**SUNDRY NOTICES AND REPORTS ON WELL**  
*Do not use this form for proposals to drill or to re-enter an abandoned well. Use form 3160-3 (APD) for such proposals.*

8. Well Name and No.  
CEDAR LAKE FEDERAL CA 725H

APACHE RESPECTFULLY REQUEST A VARIANCE TO USE A FLEXIBLE HOSE BETWEEN BOP & CHOKE MANIFOLD. SEE ATTACHMENT FOR ADDITIONAL INFORMATION.

**PECOS DISTRICT  
DRILLING OPERATIONS  
CONDITIONS OF APPROVAL**

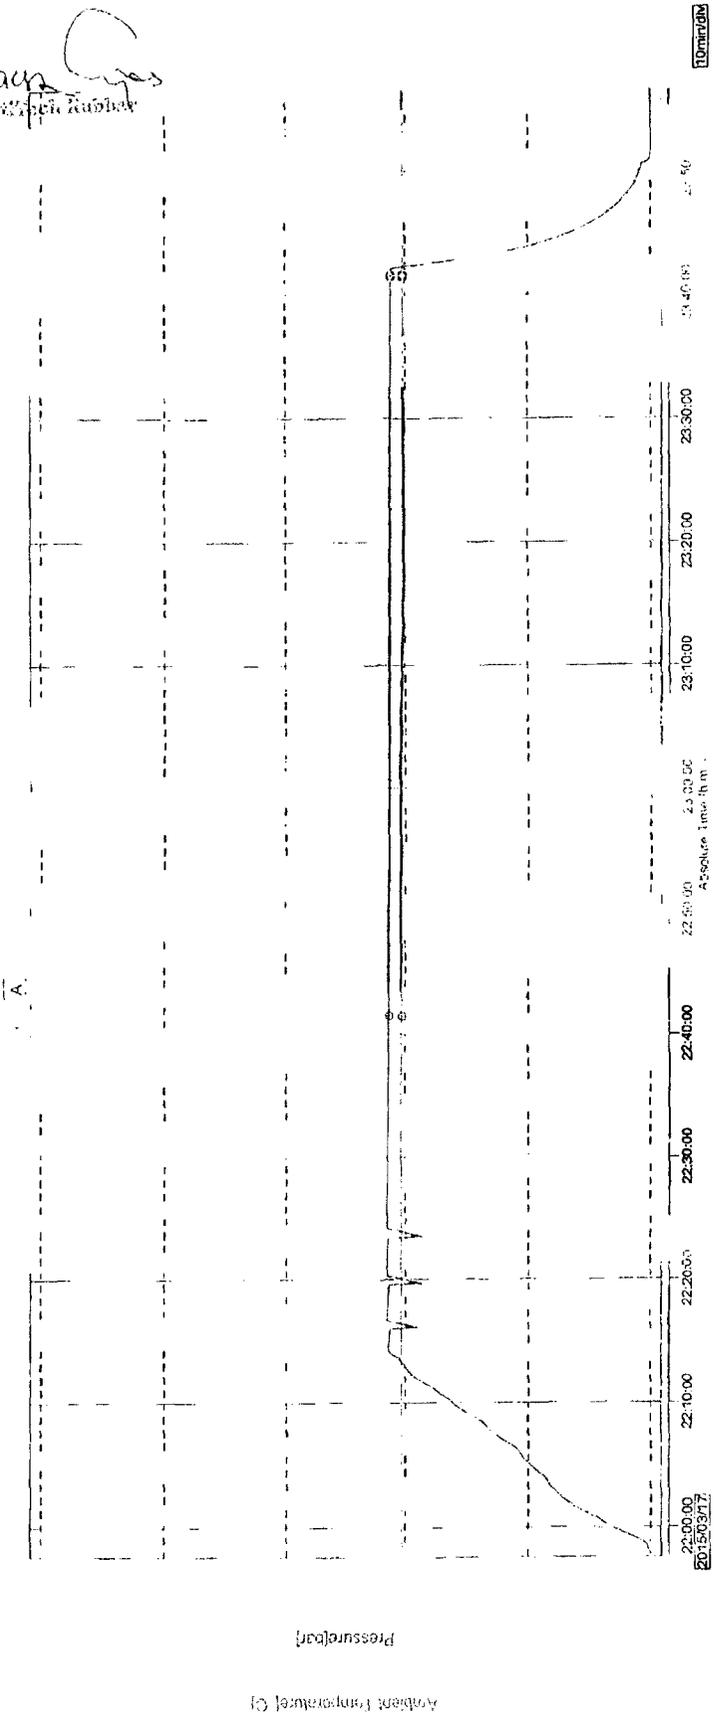
1. Variance approved to use flex line from BOP to choke manifold. Check condition of flexible line from BOP to choke manifold, replace if exterior is damaged or if line fails test. Line to be as straight as possible with no hard bends and is to be anchored according to Manufacturer's requirements. The flexible hose can be exchanged with a hose of equal size and equal or greater pressure rating. **Anchor requirements, specification sheet and hydrostatic pressure test certification matching the hose in service, to be onsite for review. These documents shall be posted in the company man's trailer and on the rig floor.** If the BLM inspector questions the straightness of the hose, a BLM engineer will be contacted and will review in the field or via picture supplied by inspector to determine if changes are required (operator shall expect delays if this occurs).
